# Calculation Cover Sheet

## Cook Nuclear Plant

CALCULATION No. <u>NESPO32395 JJS</u>	INDIANA MICHIGAN POWER COMPANY
SAFETY RELATED YES <u>X</u> NO <u>    </u>	UNIT No. <u>1</u>
SYSTEM <u>CVCS - Boron Make Up</u>	CALCULATED BY: <u>Jack T. Creiglow</u> <u>6/2/95</u> DATE
TITLE <u>Bat Pump NPSHR VS Best Level</u>	VERIFIED BY: <u>H. S. Satin</u> <u>6/26/95</u> DATE
RFC/MM/PM/PR/CR/TM No. <u>N/A</u>	APPROVED BY: <u>[Signature]</u> <u>6/29/95</u> DATE
FILE LOCATION <u>CVC</u>

DESIGN VERIFICATION CHECKLIST - CALCULATIONS

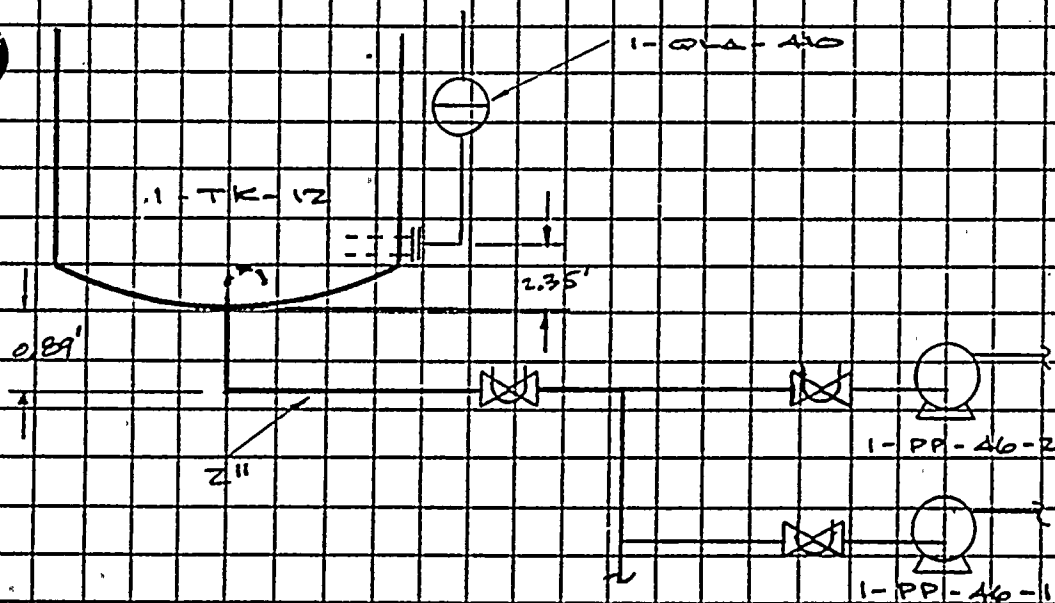
- 1) BORIC ACID SOLUTION TEMPERATURE = 120°F *here trace req'd*
- 2) BORIC ACID SOLUTION HAS SAME VAPOR PRESSURE AS WATER *NWS Boric Acid book*
- 3) ATMOSPHERIC PRESSURE = 33.96 ft H<sub>2</sub>O ✓
- 4) BORIC ACID SPECIFIC GRAVITY EQUAL TO WATER *NWS Boric Acid book*
- 5) BORIC ACID TRANSFER PUMP OPERATING AT 75 gpm. - 12-5131-33
- 6) BORIC ACID STORAGE TANK 1-TK-12N AND BORIC ACID TRANSFER PUMP 1-PP-46-1 LINED UP ✓ - most conservative line up

- 1) NPSH REQUIRED RANGES FROM 4 FT TO 10 FT  
- DESIGN POINT = 6 FT
- 2) NPSH AVAILABLE AT 7.9% ~~2.30%~~ TANK LEVEL (AS INDICATED ON 1-QLA-410) EQUALS 6.0 FT

THE MINIMUM BAST LEVEL THAT IS ACCEPTABLE TO OPERATE THE BAT PUMPS WHILE STILL HAVING ADOQUATE NPSH AVAILABLE IS 2.30% BAST LEVEL AS INDICATED BY 1-QLA-410.

$$h_{fs} = 55.715 \text{ ft of pipe} \\ = (55.71) \times 10.1 \text{ ft} / 100 \text{ ft } (\text{ANSON}) \\ = 5.62 \text{ ft} + 3(2.63) + 0.62 \text{ ft} \\ = 14.13 \text{ ft} \\ 14.28$$

THE NPSH<sub>R</sub> FOR THE BAT PUMP IS 6 FT @ 75 gpm  
THEREFORE AN ADDITIONAL 0.27 FT OF BAST LEVEL  
ABOVE 0% IS REQUIRED 0.92

$$\frac{0.27}{0.92} \times 12" = \frac{3.24}{11.04}"$$

$$\frac{11.04}{3.24} = 0.003 = 7.9\% \text{ BAST LEVEL}$$

Corrected values now reflected on revision calculation. DLR
